ANSI-ASC-C63[®] Interpretation Request Form

Submission Date	Originator Name, Company
3/2/2016	Doug Schlam, HP Inc.

Standard	Clause/ Sub clause	Paragraph Figure/ Table	Type (General/ Technical/ Editorial)	Comment / Inquiry	Subcommittee Response <i>(to be filled in by Subcommittee Chair)</i>
C63.4-2014	N.4.3.2 and similarly, N.4.3.1	<p>b) Place the receiving biconical antenna on the antenna mast in horizontal polarization at a height.... Do NOT use an attenuator on the output connector of the receiving biconical antenna.</p> <p>f) Compute the reference and AUT horizontally polarized field strength measurement results (in dBμV/m) as follows:</p> $E_{BB10H} = S_{21, BB10H} + FSAF_{biconical} \text{ (N.7)}$	Technical	<p><u>Background:</u> Biconical antennas are good antennas, but not ideal. The VSWR of a biconical antenna in the low end of its frequency range is not very good. A half-wave-dipole would be closer to ideal, but its length at 30 MHz (5 m end-to-end), for example, makes its use prohibitive. If a 6 dB attenuator is used with the hybrid antenna, the VSWR is reduced significantly. The equations (N.9, N.12) in the standard, compare the hybrid antenna (with a HAIMP) to the bico

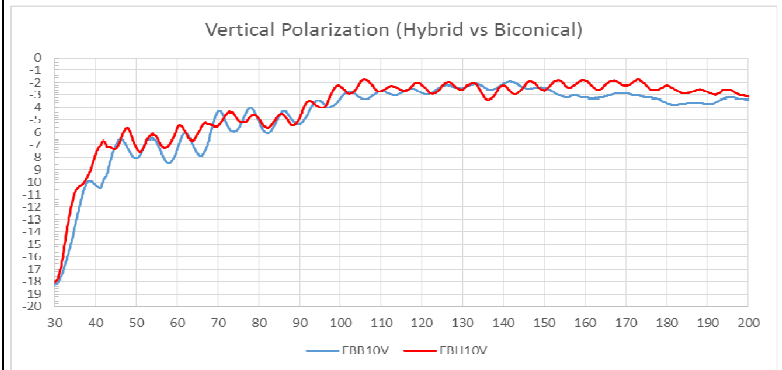
Example at 40 MHz:
 If I compare a CBL6112D to an ETS Lindgren 3110C, I get the trace below for vertical polarization:

The trace above shows fairly close amplitudes (<2.4 dB, the maximum allowable difference), but a lot of reflections in both traces. In my particular case, I show non-compliance (maximum delta is 3.4 dB) around 40 MHz.

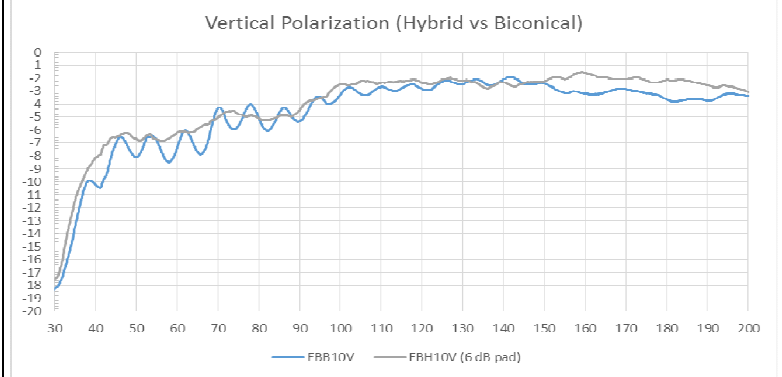
Once I am resigned to using a 6 dB attenuator, the red trace above becomes the gray trace below:

Notice that the hybrid antenna (gray trace) now has significantly less reflection (maximum delta is 2.6 dB). The biconical antenna still has significant reflection. The ANSI C63.4-2014 Annex N guidance has gotten me to a point wherein I am improving the VSWR of the hybrid antenna to the point that it has less reflection than the biconical antenna without an attenuator. In essence, my hybrid antenna now has less VSWR than the biconical antenna (without a 6 dB attenuator), however, it still does not meet the 2.4 dB requirement.

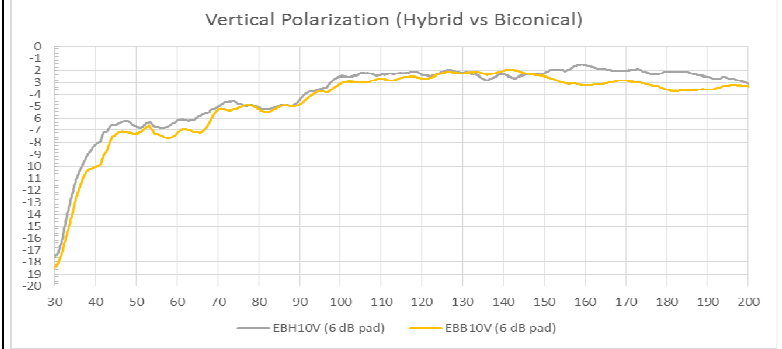
To test my conclusion, I repeated the test with a 6 dB attenuator on the biconical antenna (the blue trace above becomes the yellow trace below):

Changing the scheme from Annex N to affix the same value attenuator to the biconical antenna (as was affixed to the hybrid antenna), I show a maximum delta of 2.0 dB. Although a very good antenna, the biconical is not ideal. The VSWR of the biconical antenna should not penalize the qualification of the hybrid antenna.

Standard	Clause/ Sub clause	Paragraph Figure/ Table	Type (General/ Technical/ Editorial)	Comment / Inquiry	Subcommittee Response <i>(to be filled in by Subcommittee Chair)</i>
				<p><u>Proposal:</u> Changing the scheme to affix the same value attenuator to the biconical antenna (as was affixed to the hybrid antenna), levels the playing field. For example, adding a 6 dB attenuator to the biconical antenna, reduces the VSWR at 30 MHz to approximately 1.4:1. This is better than the hybrid antenna (with attenuator) and serves as a good reference.</p> <p>from: $E_{BB10H} = S_{21, BB10H} + FSAF_{biconical}$ (N.7) to: $E_{BB10H} = S_{21, BB10H} + FSAF_{biconical} + L_{HAIMP}$ (N.7)</p> <p>from: $E_{BB10V} = S_{21, BB10V} + FSAF_{biconical}$ (N.10) to: $E_{BB10V} = S_{21, BB10V} + FSAF_{biconical} + L_{HAIMP}$ (N.10)</p> <p>Corresponding changes should also be made to N.4.3.1 for 3 m test sites.</p>
